## SUPPLEMENT

# RCA Victor Radiola R-11 Service Notes

Figure 1—Revised Schematic diagram of late production R-11

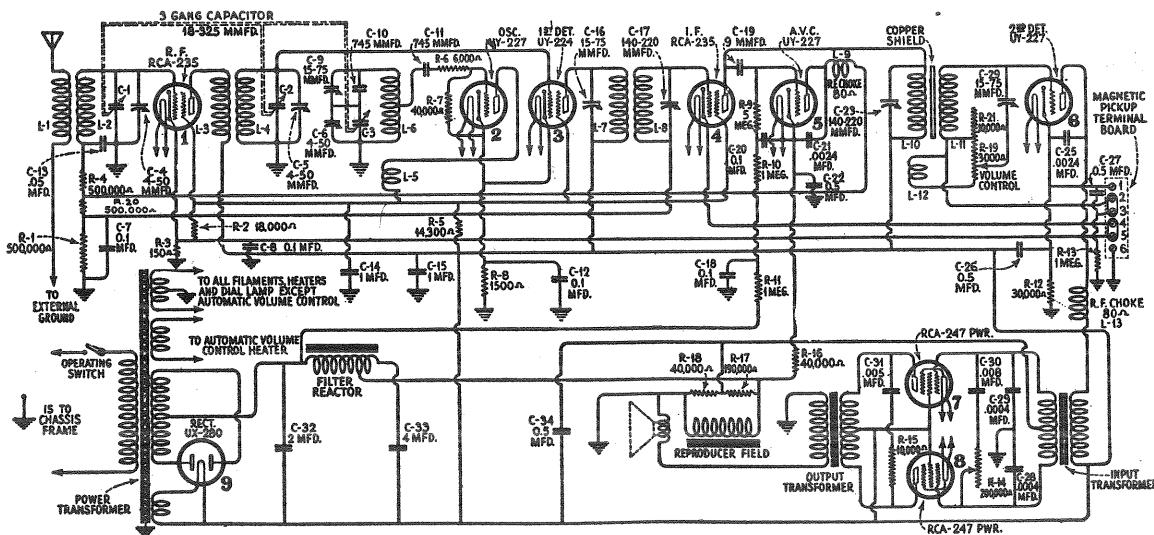
Late production of the RCA Victor Radiola R-11 has a slight change in the wiring, two changes in capacitor values and the addition of a 0.5 megohm resistor (R-20). Capacitor C-7 has been changed from 0.5 mfd. to 0.1 mfd. and C-13 from 0.1 mfd. to 0.05 mfd. Resistor R-20 has been added.

Figure 2—Wiring diagram of late production R-11

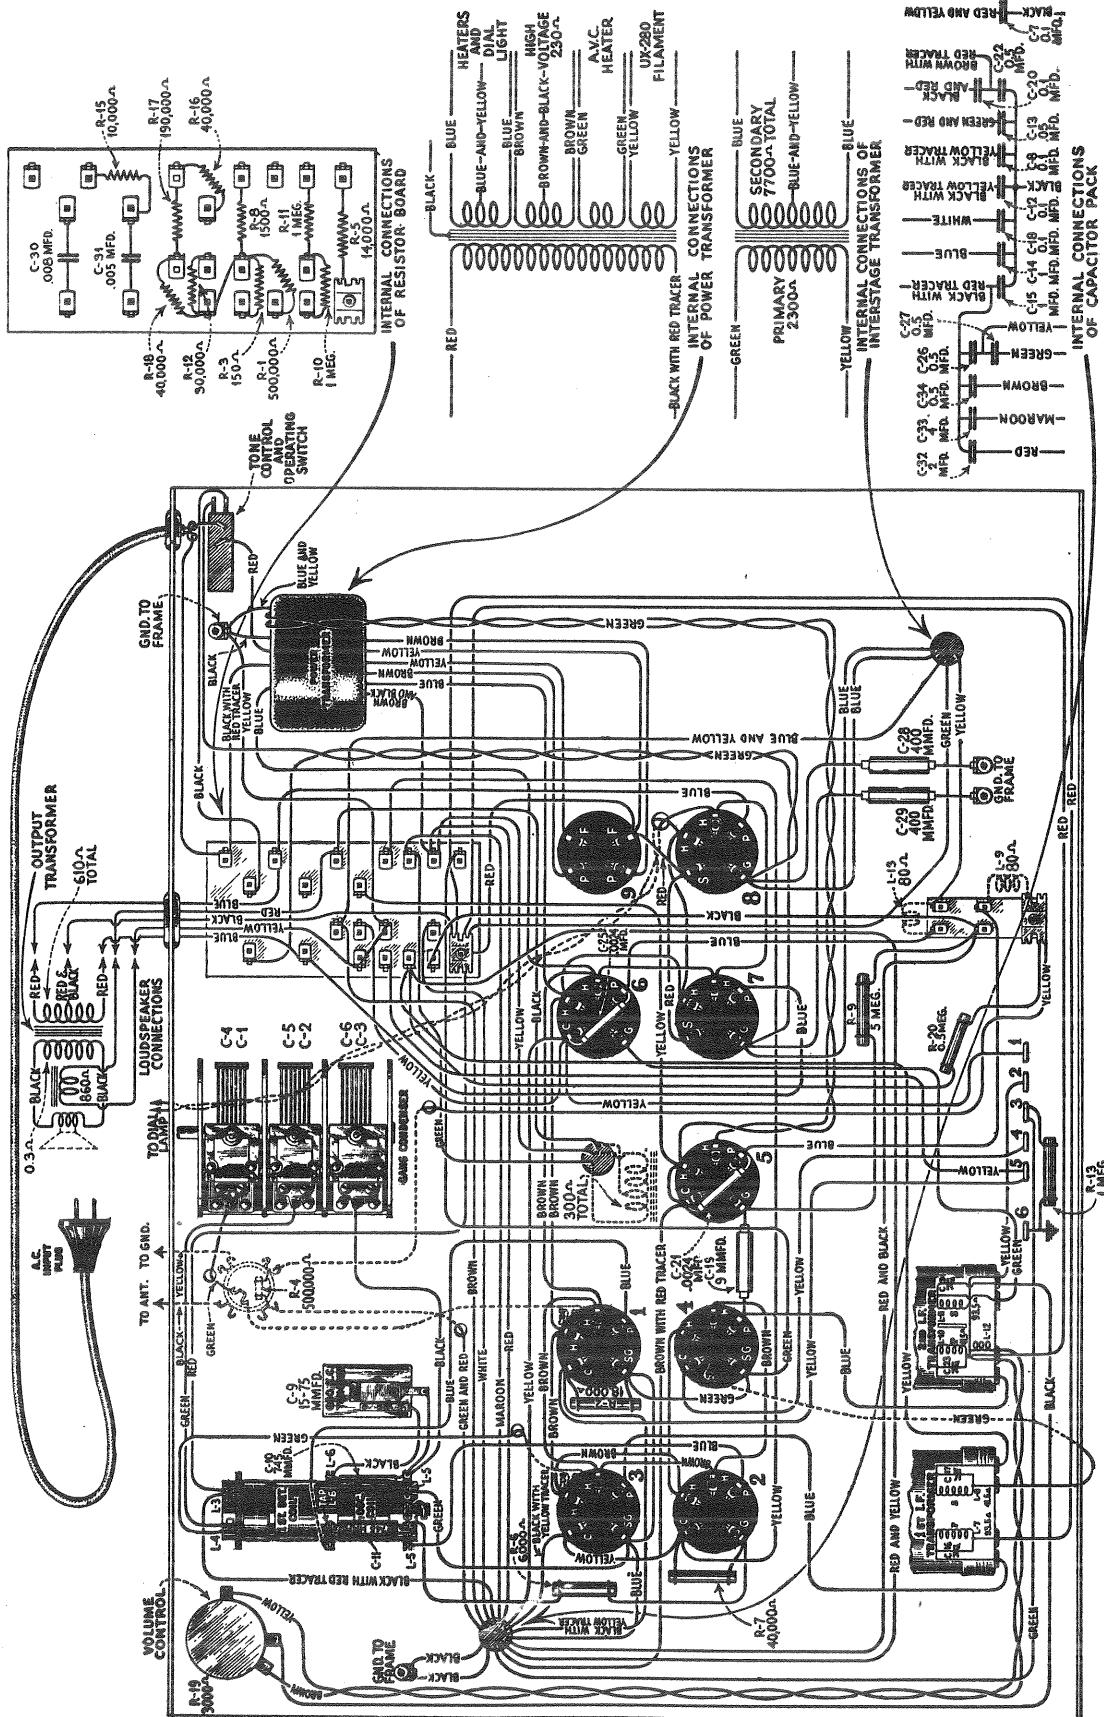
The replacement parts listed and supplied are entirely interchangeable with either the old or new models. In the case of the older models, however, the additional black lead supplied in the new capacitor pack should be joined to the old black ground lead. All other capacitor leads are exactly the same and are soldered to the same points.
